Service Bulletin

Bulletin No.: 18-NA-069

Subject: Poor Engine Performance in Extremely Cold Weather Conditions for LFB Engines, Charge Air Cooler Icing - Malfunction Indicator Lamp (MIL) Illuminated, DTC P0299, P0236, P2227, P00C7 Set

Brand:	Model:	Model Year:		VIN:		Engine:	Transmission:
		from	to	from	to		
Chevrolet	Malibu	2016	2020			1.5L (RPO LFB)

4241877

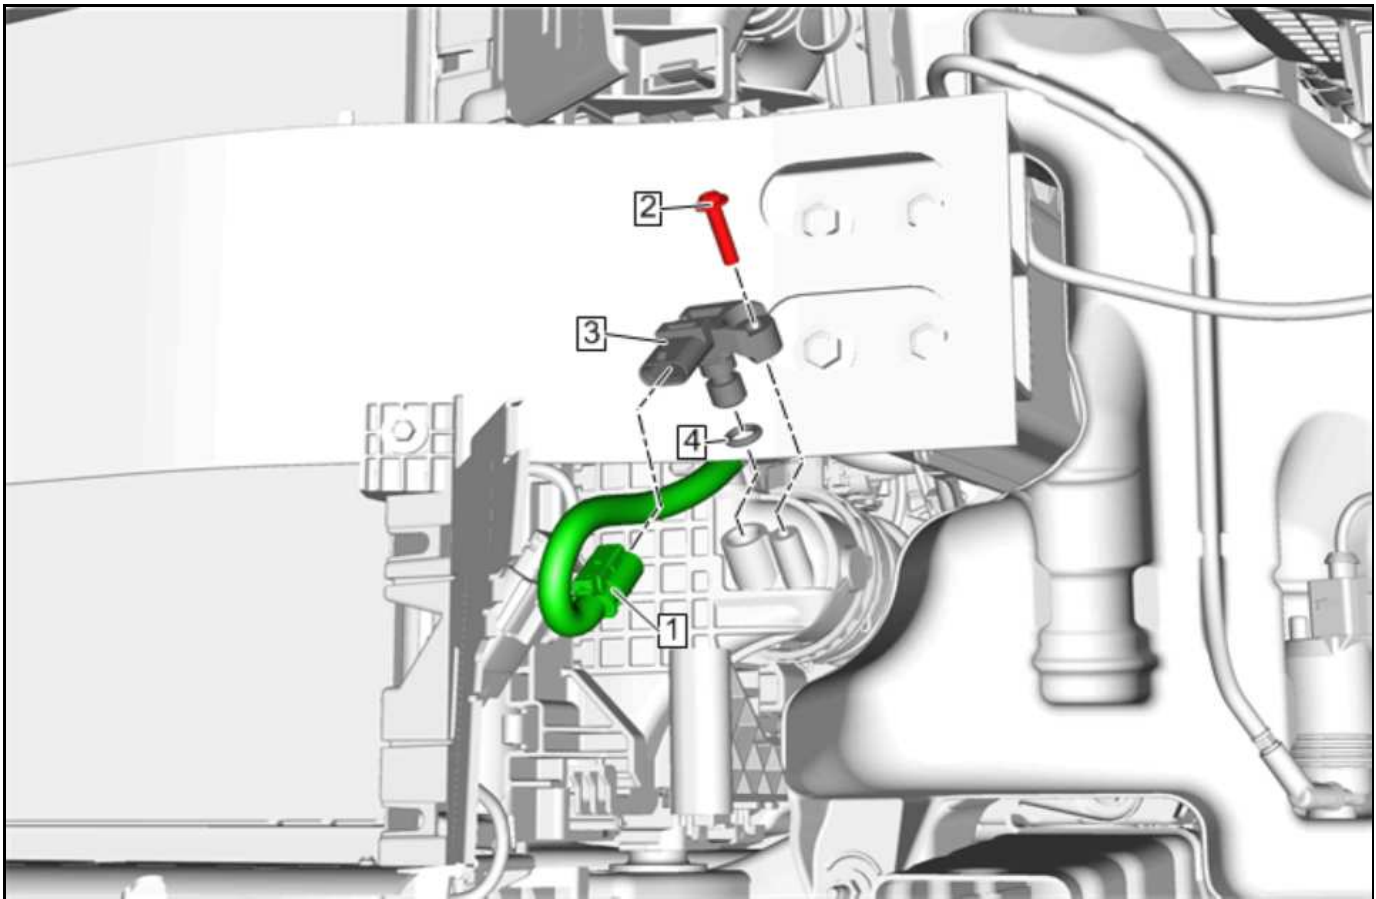
1. Install the CAC (2). Refer to *Charge Air Cooler Replacement* in SI.

4233269

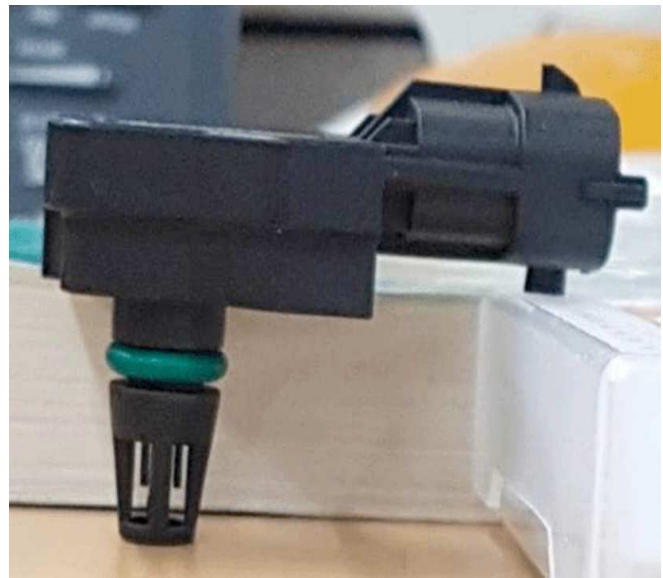
3. Remove the Turbocharger Air Pressure sensor (3). Refer to *Turbocharger Air Pressure Sensor Replacement* in SI.
